REGIONAL REVIEW NOTICE

ARC REVIEW CODE: R15072001

Name of Proposal: Riverwalk Village

SUBJECT: **Transportation Division Review of DRI # 2456**

GRTA Site Plan

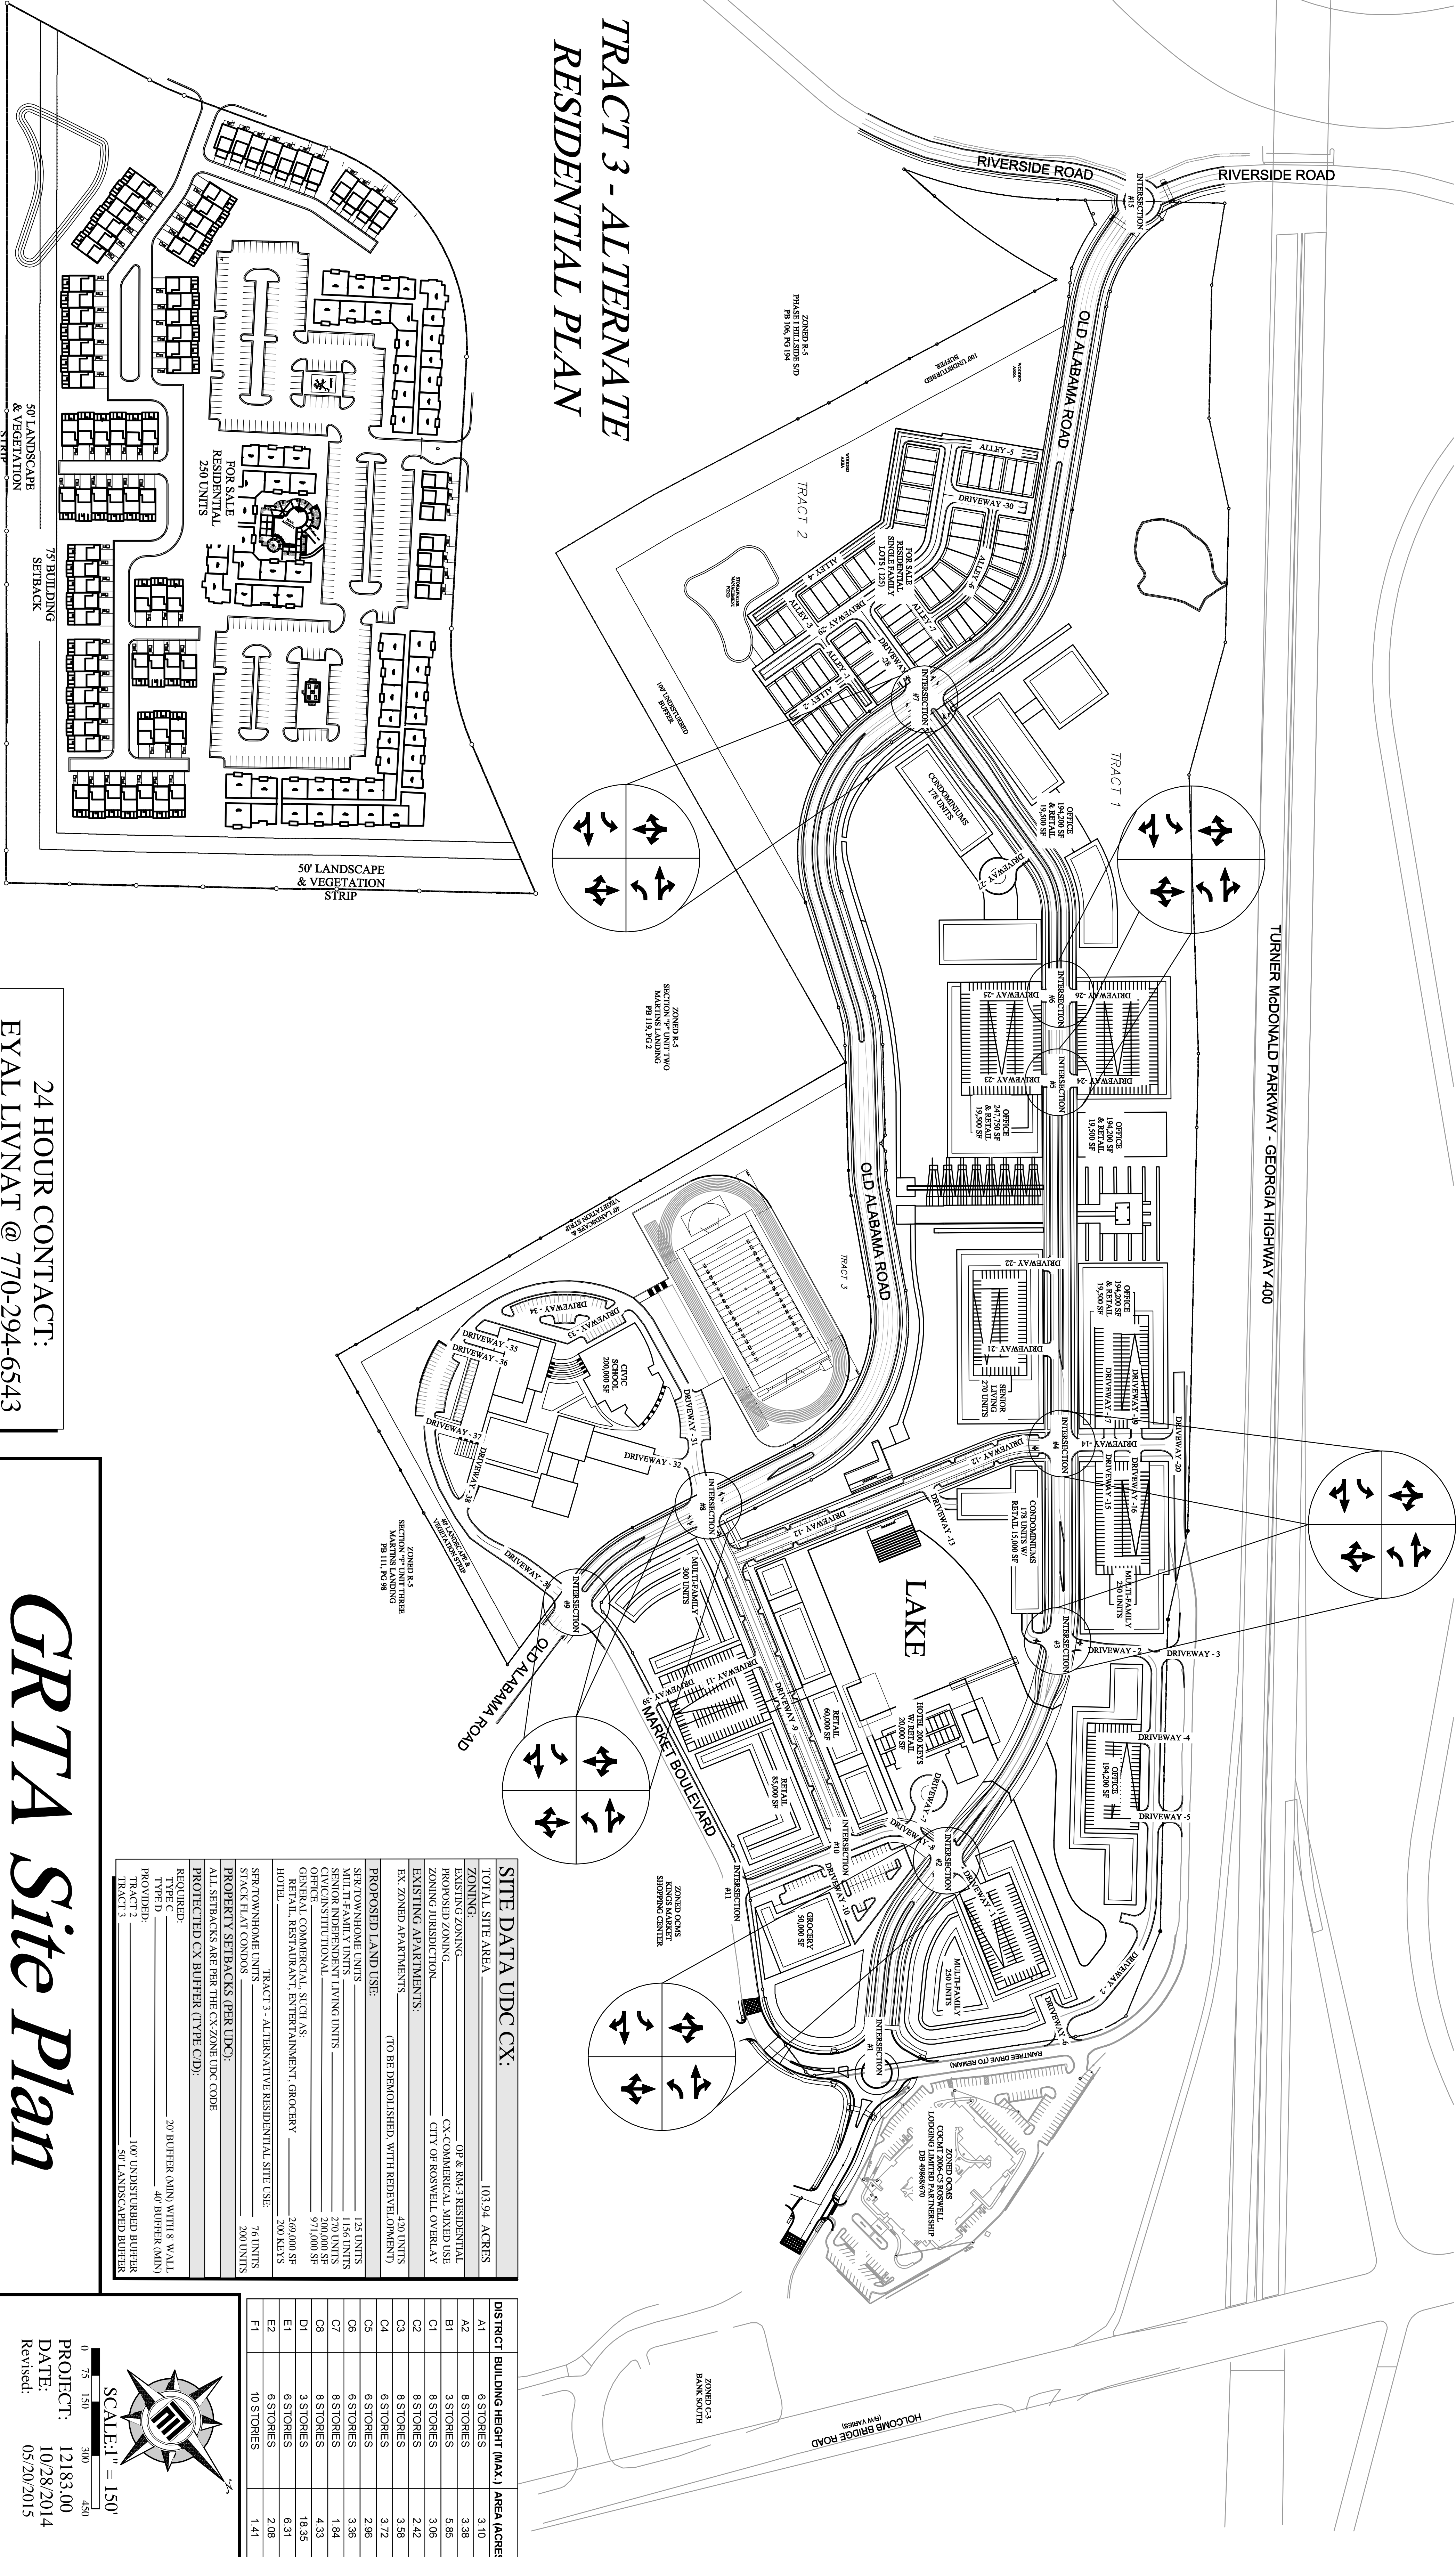
The site plan and supporting materials indicate the developer's desire to create a mixed-use, walkable development. As such, all buildings should "front" public streets and parking should be behind or beside buildings and screened from view. It appears that several parking lots or decks may be proposed for the Market Boulevard and other internal roads located in the northern portion of the site.

The site plan includes an alternative use for Tract 3. This alternate includes residential instead of civic uses. The current propose layout of the residential plan for Tract 3 includes two separate driveways that each serve separate pods of development. The developer should consider integrating the two pods and allowing all of Tract 3 to utilize the two driveways.

There is some concern with the spacing between Intersection #8 and the Intersection of Driveway 12 and Driveway 9 (not labeled). The current spacing may not allow for adequate storage of left turning vehicles, once they have entered the site. The developer should consider increasing the distance between these two intersections or limiting turning movements between Driveway 9 and Driveway 12.

The intersection of Driveway 9 at Driveway 12 appears to be within 100 feet or less of Intersection 8. Driveway 12 should be moved further from Intersection 8. If this is not possible due to the location of the existing lake, then the intersection of Driveway 9 at Driveway 12 should allow right-in/right-out movements only. This will reduce the impacts of queueing and other issues from the intersection of Driveway 9 at Driveway 12 on Intersection 8.

If the early off-ramp project is implemented, then Driveways 3, 4, 5, and 6 may not be permitted by GDOT and/or the City of Roswell, due to the need to limit access on this connection from SR 400. Additional coordination with GDOT and the City of Roswell should be conducted to determine the viability of these proposed driveways.

A least one viable location for an external roadway and bike/ped connection should be provided on both the east and the south sides of Tract 2.

The site plan shows parking provided throughout the development. Details about the number of parking spaces provided and their locations should be provided in the traffic report or identified on the site plan.
